Re: Objection to Application of Union Milling Company, LLC
Leadville Mill – File No. M-1990-057
Permit Conversion Application (CN-3)
Conversion to 112(d) Designated Mining Regular Operations Permit

**JVA Consulting Engineers Memorandum
March 18, 2024**

TO:	<u>District Board</u>	DATE:	<u>March 18, 2024</u>
FIRM:	<u>Leadville Sanitation District</u>	JOB NO.	<u>1119.2e</u>
ADDRESS:	<u>911 US Hwy 24</u>	PROJECT:	<u>Union Milling – Permit M1990-057</u>
	<u>Leadville, CO 80461</u>	SUBJECT:	<u>District Engineer Objections</u>

Figure 1. Existing Sanitary Sewer line.

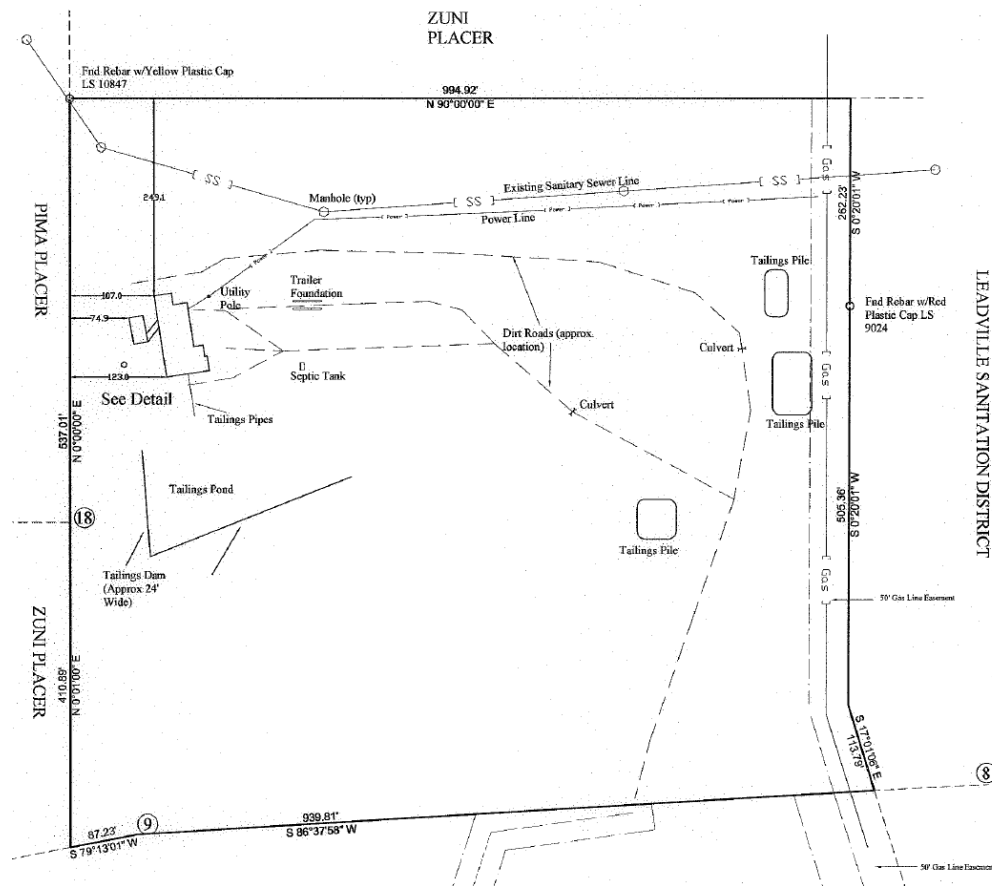
The report states the Area 100 Crushing Circuit will maintain low seismicity. Although the applicant indicates low seismicity, JVA is still concerned about potential disturbance and impacts to the District's collection system. The District collects and treats wastewater from downtown Leadville as well as developments located west of Leadville. Wastewater flows by gravity through the collection system to the WWTF. Figure 1 below shows the District's existing sanitary sewer line that contains significant wastewater flows that could be directly impacted by the new crushing facility.

The new crushing facility could impact the collection system by disturbing the manholes, pipes, and service lines resulting in an increase in the infiltration of groundwater into the collection system. This increase in infiltration is in direct conflict with the CDPHE compliance schedule to reduce inflow and infiltration into the collection system. Damage to the collection system could also result in exfiltration or seepage of wastewater into the ground which would be a direct violation of the Clean Water Act. The cost of repair of this infrastructure would fall to the Sanitation District and the residents of Leadville. The District's WWTF consists of a headworks for screening and grit removal, two aeration basins, two covered clarifiers, a polishing pond, and a chlorine contact chamber for disinfection. Nearby seismic activity from the proposed Mill could also have detrimental effects to the existing WWTF structures that are required for wastewater treatment and permit compliance.
